PLANNING & ZONING CASE NO. SP2021-018

PROJECT NUMBER: SP2021-018
PROJECT NAME: Site Plan for Lakeshore Office Building
SITE ADDRESS/LOCATIONS: 1942 N LAKESHORE DR

06/25/2021: SP2021-018; Site Plan for a Lots 2 & 4, Block A, North Lake Shore Daycare Addition
Please address the following comments (M= Mandatory Comments; I = Informational Comments)

REDESIGNED SITE PLAN

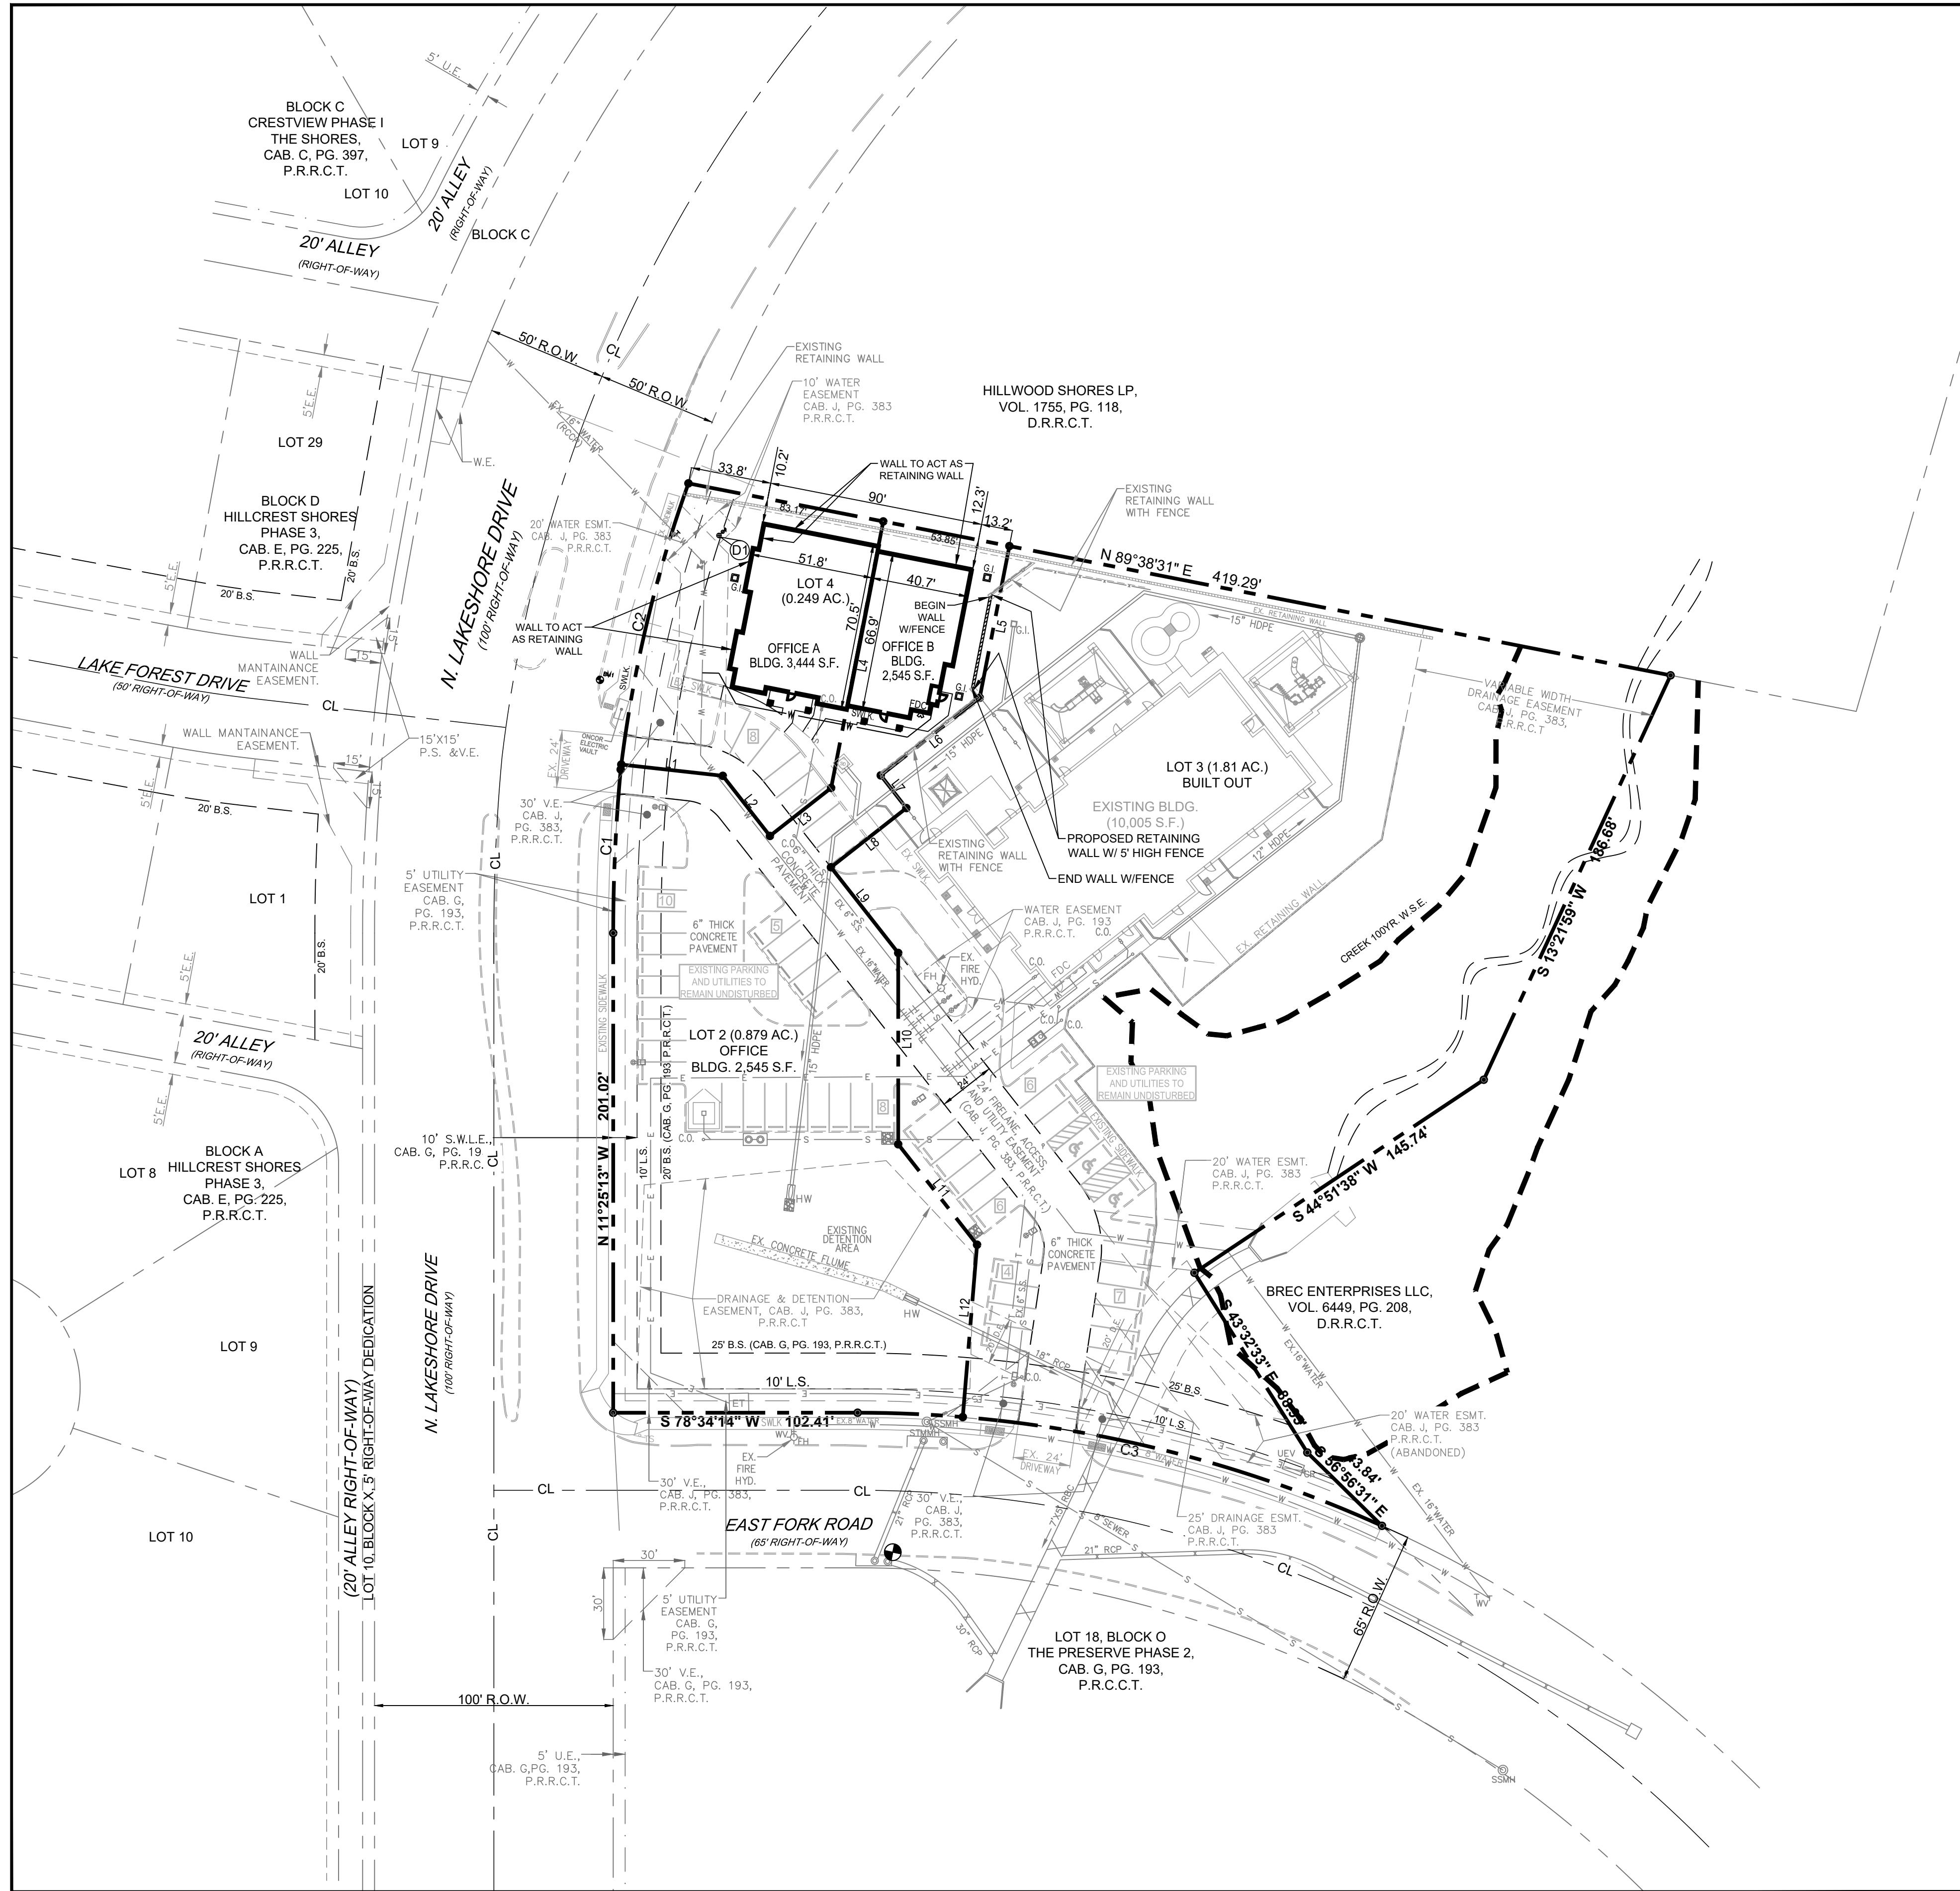
M.9 Site Plan. Please make the following clarifications on the site plan to ensure staff can properly review this project and convey all of the required elements to the City's boards

- 1) Mechanical Equipment Screening. Are the units on the ground or on the roof? If on roof, dash-in RTU's or indicate on building elevations. If ground mounted, indicate locations on site and provide screening detail - All buildings shall be designed so that no HVAC, satellite dishes, appurtenances and/or any other mechanical equipment visible from any direction. This shall include equipment located on the roof, on the ground, or otherwise attached to the building or located on the site? Provide screening detail. (§06.02.C.3, of Art. 05, UDC)

- 2) Remove the 'R.O.W Dedication' label from the Site Data Summary Table if not dedicating ROW. If dedicating, hatch and label area to be dedicated.
- 3) Will there be a trash dumpster for the subject property? If so, enclosures shall be four (4) sided, shall be screened by a minimum eight (8) foot, solid masonry dumpster enclosure that utilizes the same masonry materials as the primary building and incorporates an opaque, self-latching gate. Provide detail. (§06.02.D.7, Art. 05,UDC)

EXTERIOR
ELEVATIONS
A3.1

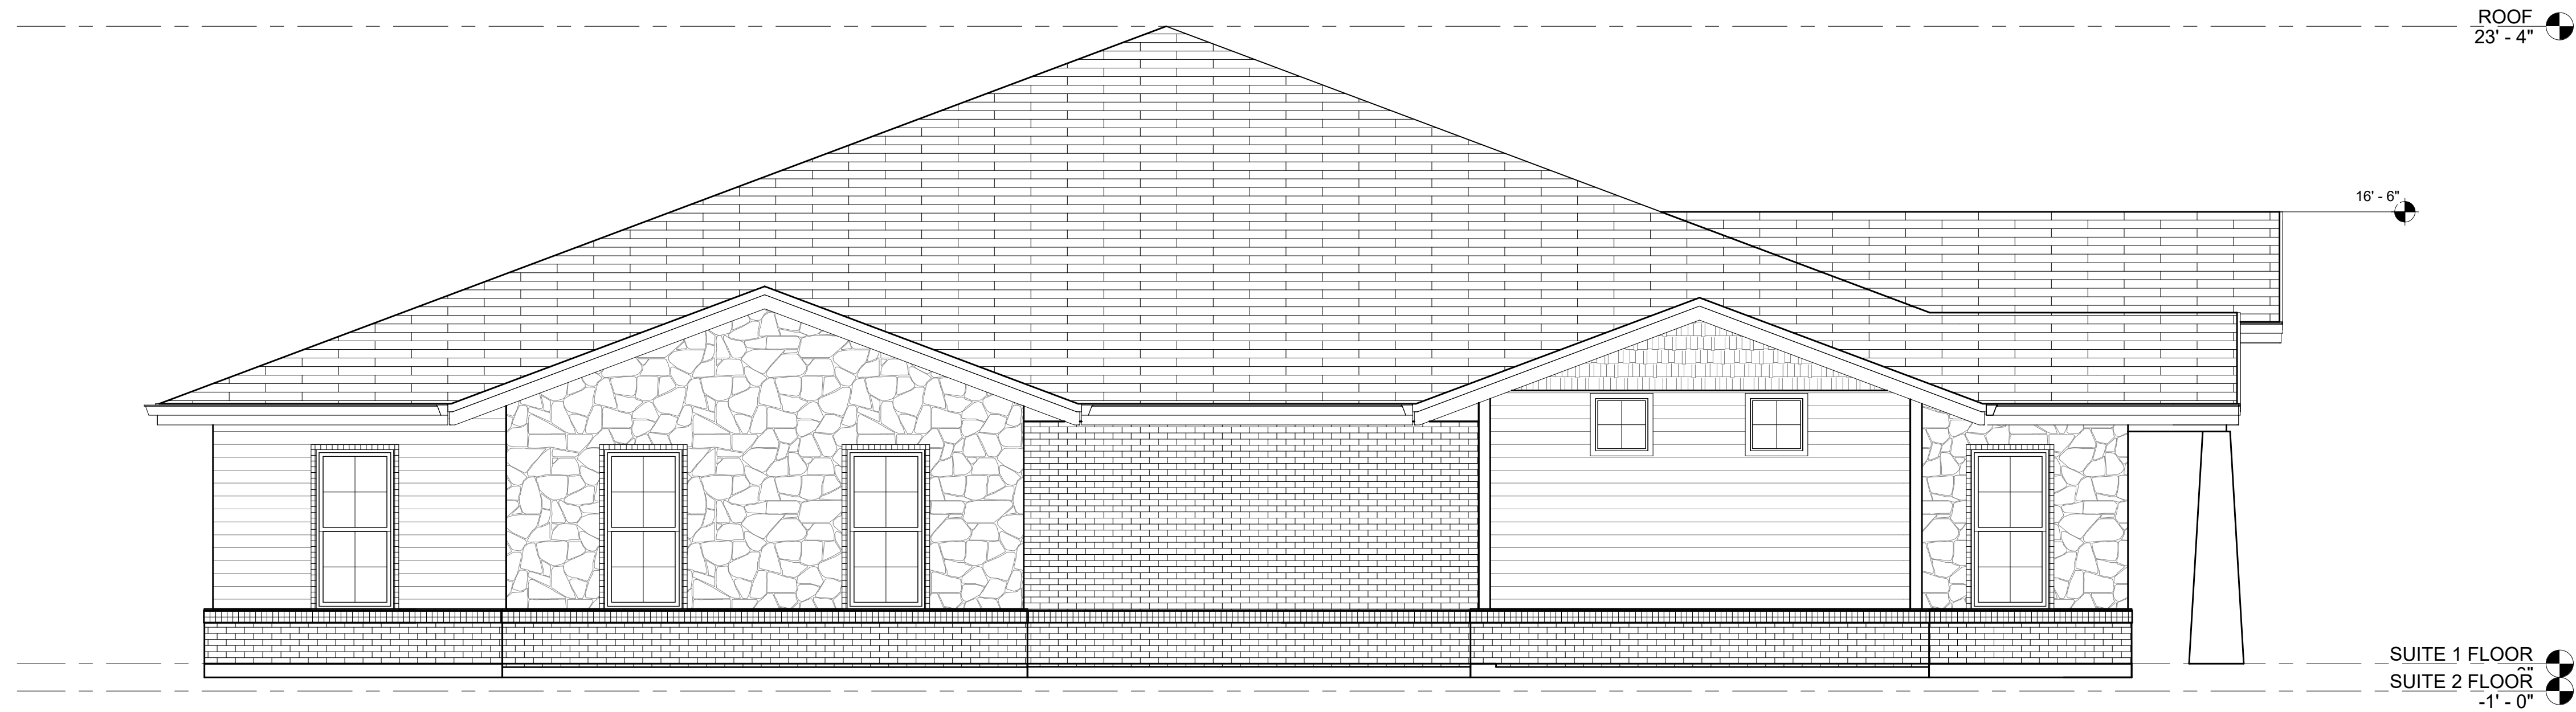
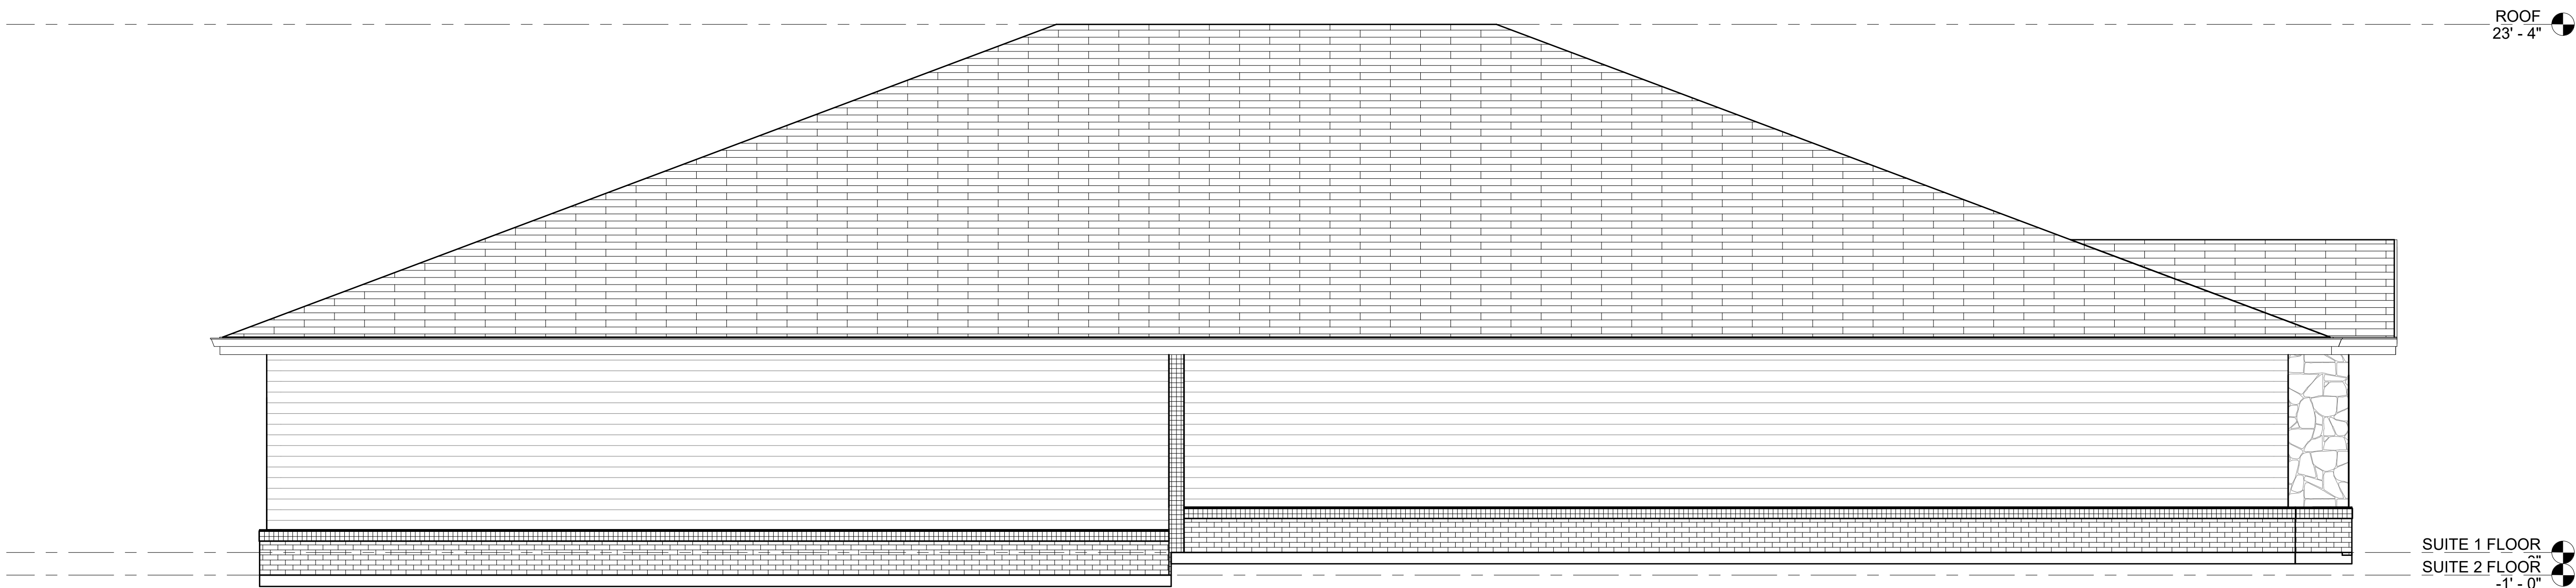
M.13 Building Elevations. Requires review by the Architectural Review Board (ARB) and a recommendation from the ARB forwarded to the Planning and Zoning Commission for consideration.

- 1) Recalculate exterior materials for each façade by removing the calculation for the roof shingles. Additionally, are these architectural roof shingle? (§06.02.C.1.a.3.a, Art. 05,UDC)
- 2) Exterior Material Samples Board (MSB) is required for Architectural Review Board (ARB) review. Provide an MSB prior to the ARB meeting to be held on June 29, 2021. (§03.04.A, Art. 11, UDC)

- 1) Building Articulation – As depicted, the building elevations do not meet the articulation standards as required in Figure 7 of Subsection 04.01.C, of Article 05, of the UDC for the following: (§04.01.C, Art. 05,UDC)
 - a. Wall projections (i.e. horizontal articulation – north elevation)

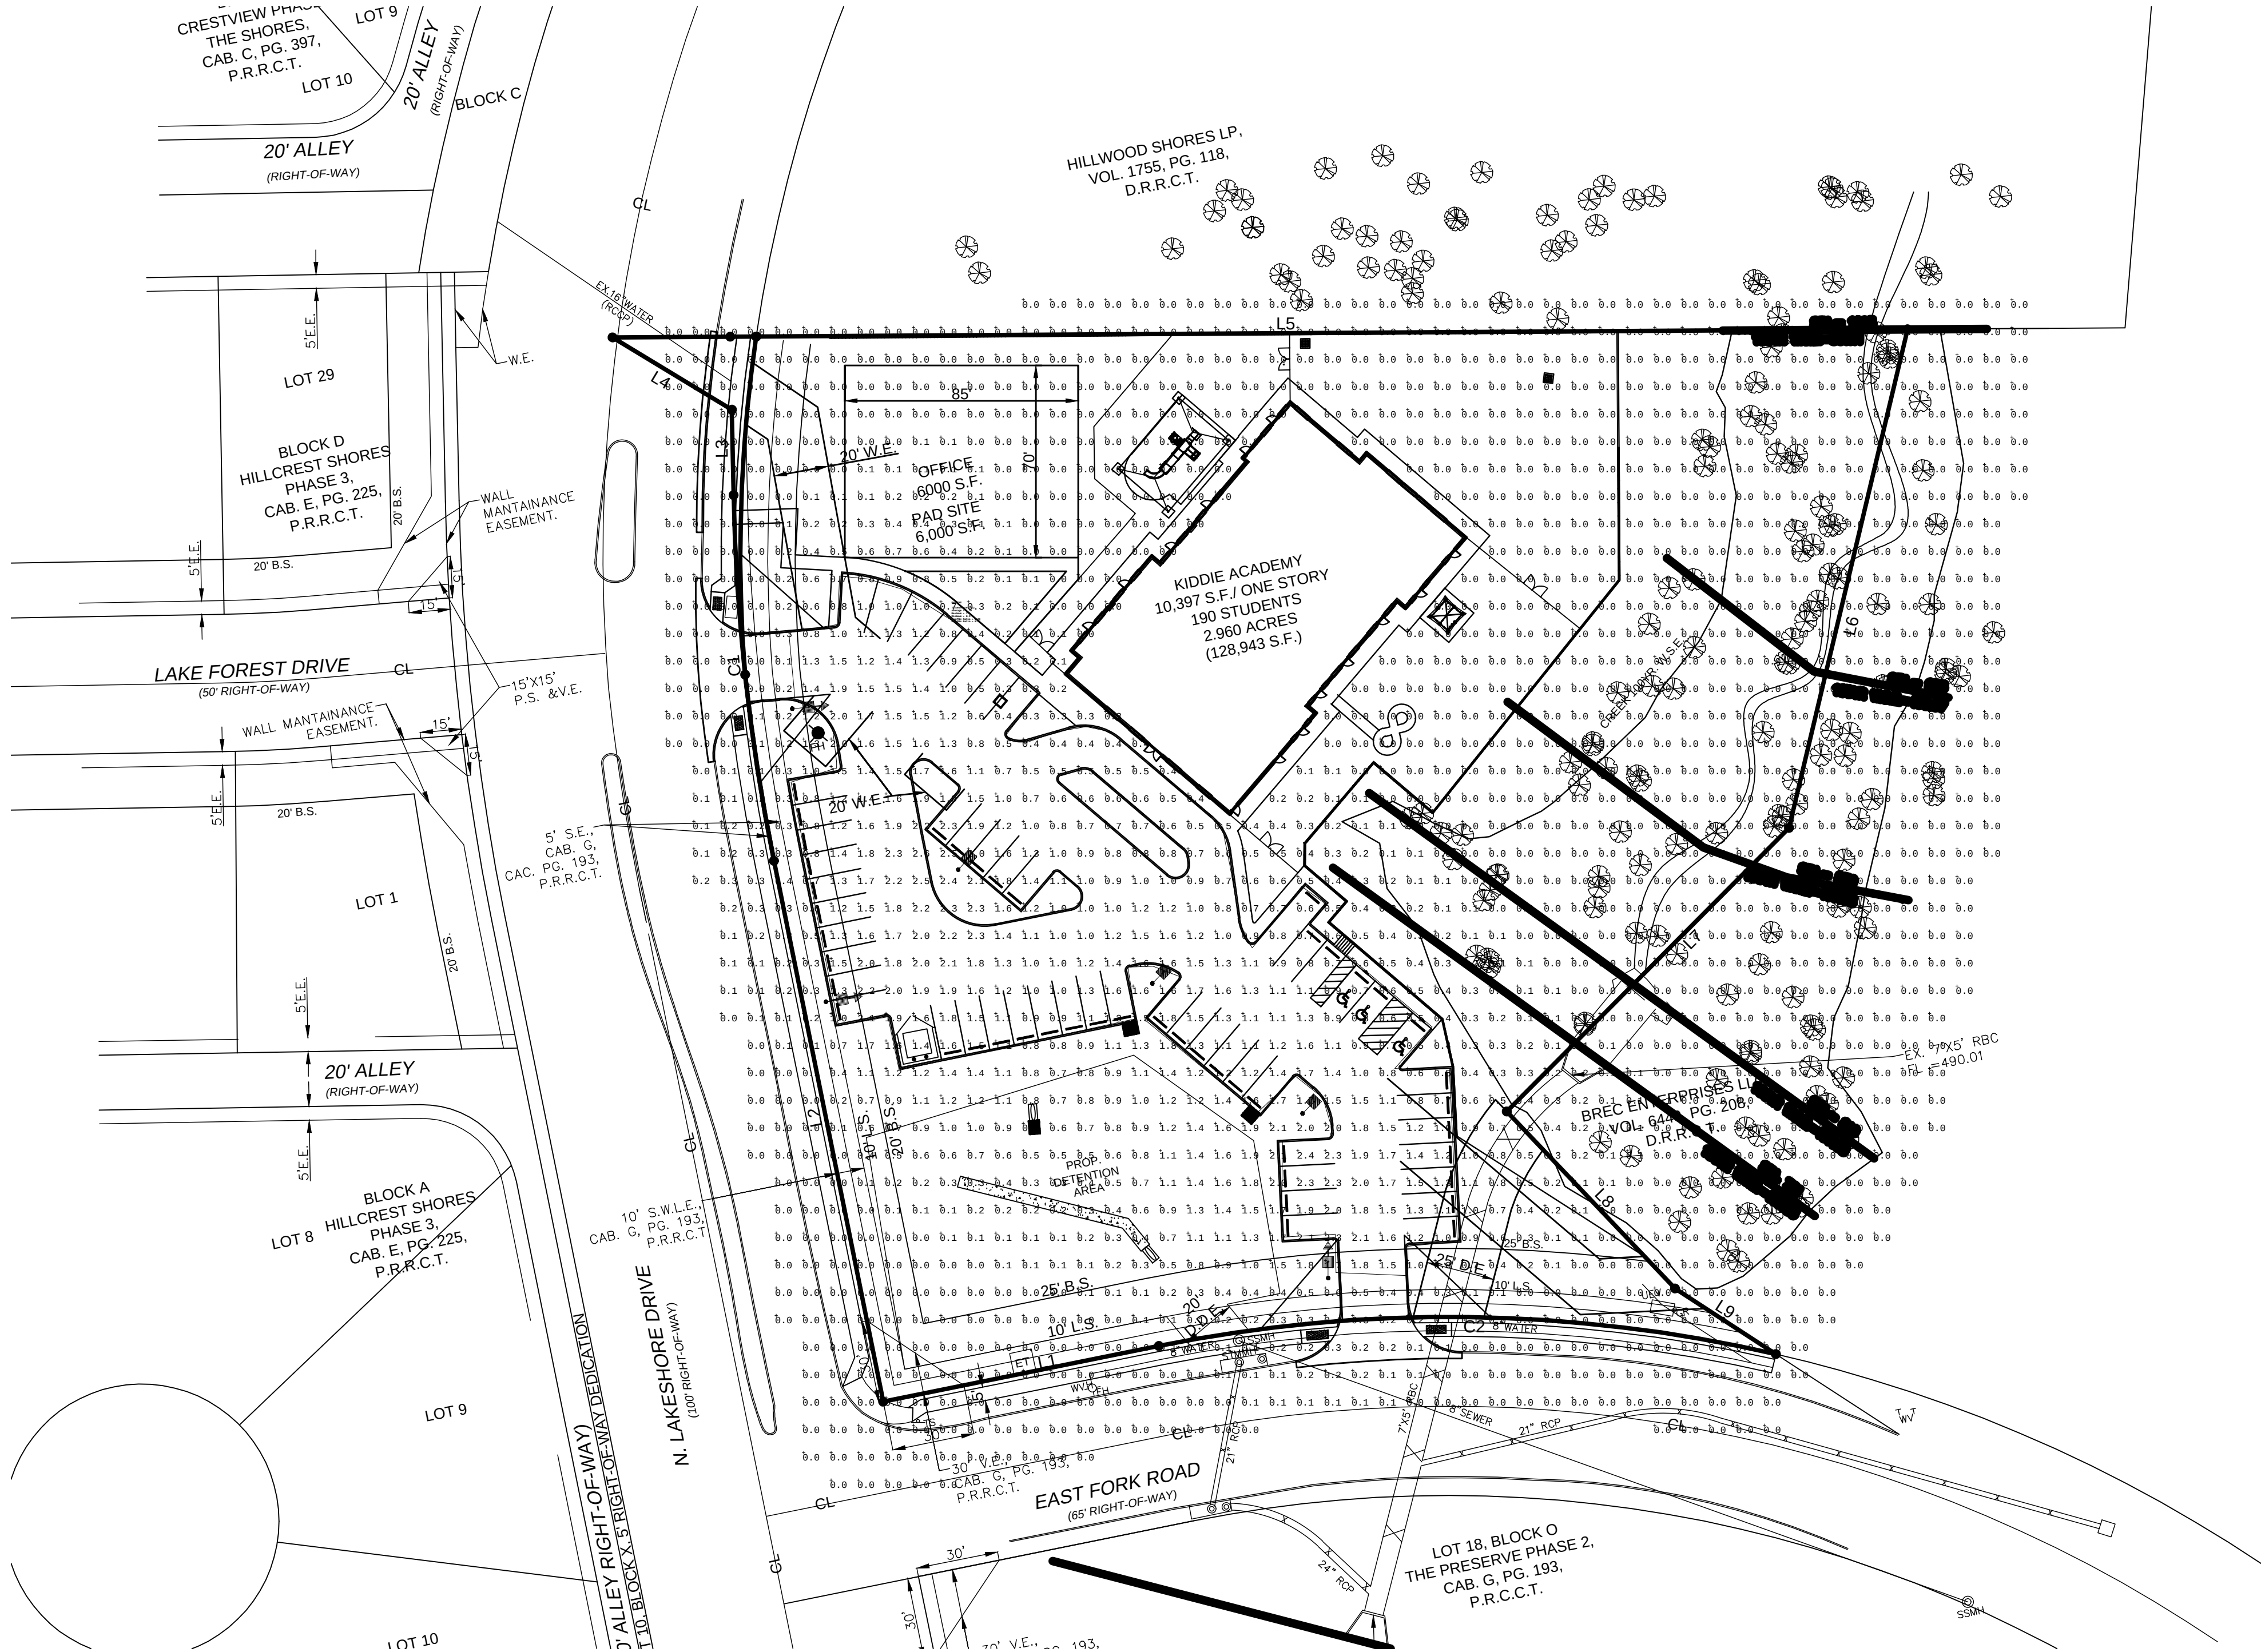
M.12 Photometric Plan. Please make the following clarifications and changes to the photometric plan to ensure staff can properly review this project and convey all of the required elements to the City's boards and commissions (§01.02, Art. 11, UDC):
